Docket Nos. 50-289 & 50-320

REVISION TO SOURCE TERM AND SYSTEM DIAGRAMS - THREE MILE ISLAND, UNITS 1 & 2

Plant Name: Three Mile Island, Units 1 & 2
Licensing Stage: OL & Post CP
Docket Numbers: 50-289/320
Responsible Branch: Environmental Projects Branch No. 3
Project Leader: W. Regan
Description of Response: Not applicable
Review Status: Complete

VENTILATION SYSTEM, THREE MILE ISLAND NUCLEAR STATION - UNIT 2

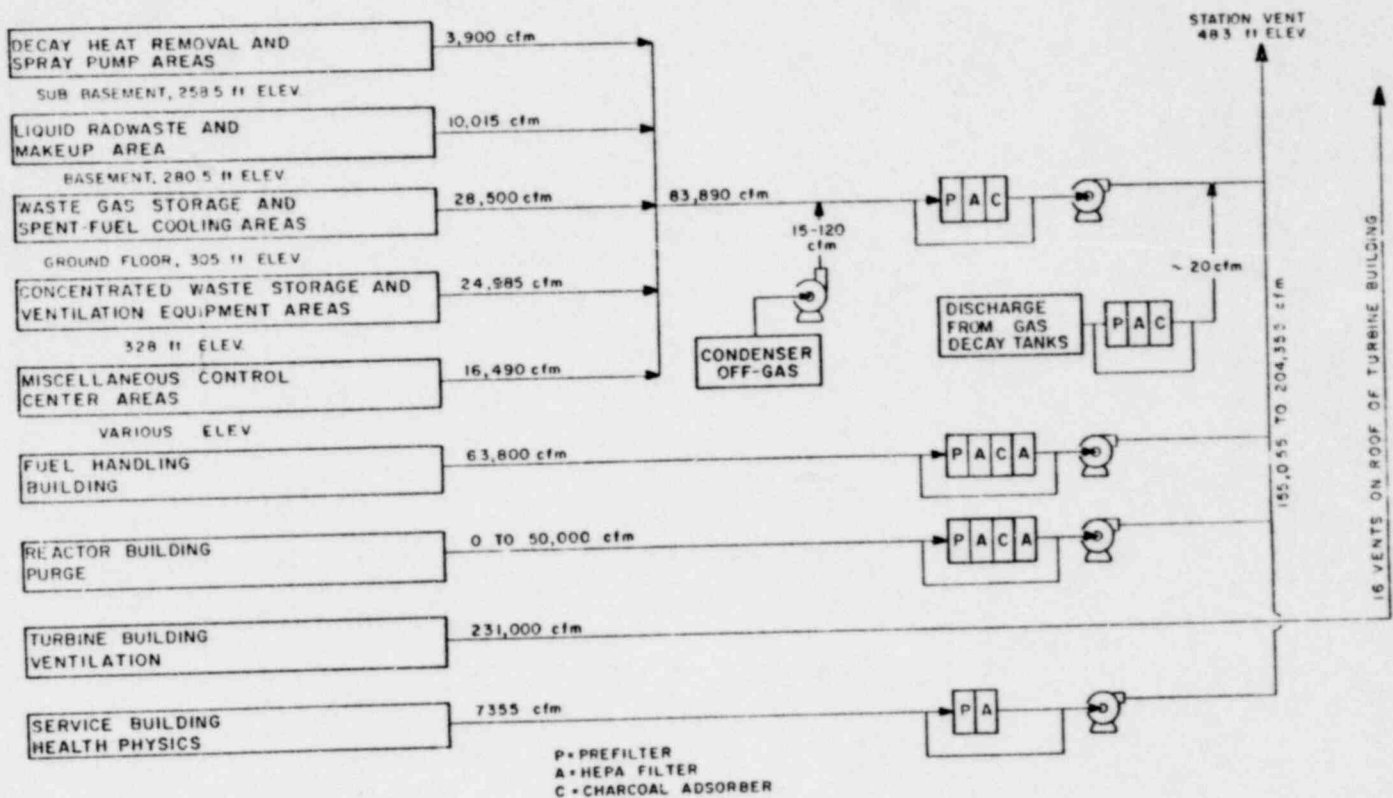
Enclosed are revised glossy prints for figures 10 and 12 in the Draft Environmental Statement (DES) which are based on comments 3 & 4 contained in the applicant's letter to you dated August 28, 1972. The source terms have been revised to account for changes in treatment of liquid and gaseous waste and are enclosed. Also, the first paragraph of the "Liquid Wastes" section on page III-17 should be revised to read as follows":
